**From:**  
**To:** [Audra Dye](#)  
**Subject:** [EXTERNAL] Fwd: 1419 Seyburn - Historic Application  
**Date:** Thursday, July 6, 2023 10:33:55 AM  
**Attachments:** [image001.png](#)  
[image.png](#)  
[image.png](#)

### **Window Replacement (excluding the windows that are proposed to be resized)**

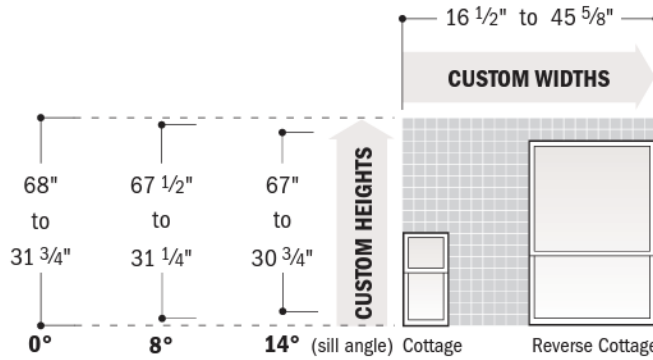
--Please measure one of the double-hung windows (as shown on the attachment) so staff can compare the proposed replacement to the existing

My plan for replacement is to exactly match the size and style of all historic windows except the ones I noted for a size change. I didn't see which window you wanted a measurement of, but that big window on the front porch is 47x60.

COTTAGE 1-HIGH

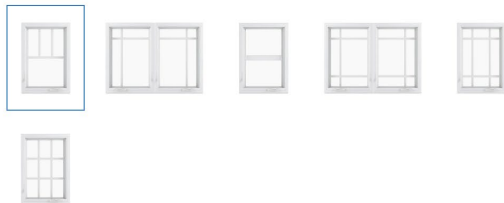
--Please submit cut sheets for the fiberglass window and sliding door, confirming design, material, finish and color. I didn't notice a dimension stated for the French doors.

I'm waiting on a cut sheet for the exact size, but it will match the existing dimensions (28x61) and is made by Marvin Infinity in the Cottage 1-High Casement style. <https://www.infinitywindows.com/windows/casement>
